PRODUCT
SUPPORT
BULLETIN # 387

TOOL(S) \ PRODUCT(S) AFFECTED : 6380-51, 6390-20, 6390-21, 6394-20 7-1/4" Til-Lok® Handle Circular Saw

SUBJECT: 45-06-0075 Felt Seal

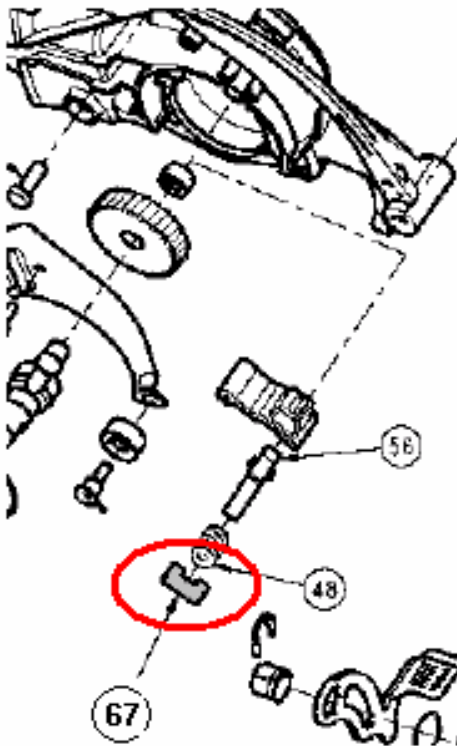
Original manufacture of the 7-1/4" Til-Lok® Handle Circular Saw had a **Felt Seal 45-06-0075** as part of the Spindle Lock assembly.

A running change is being made and 7-1/4" Til-Lok® Handle Circular Saws will no longer be manufactured with a 45-06--0075 Felt Seal [fig 67]. For service on a 7-1/4" Til-Lok® Handle Circular Saw the same is true, the felt seal is no longer needed and should be discarded if in need of replacement. Status of 45-06-0075 felt seal has been changed to obsolete, no longer available, with no-replacement.

This bulletin is for informational purposes. PLEASE NOTE ON SERVICE PARTS LIST; **120V** - 54-40- 6000, -6001 , -6025, -6050
240V - 55-40-6000
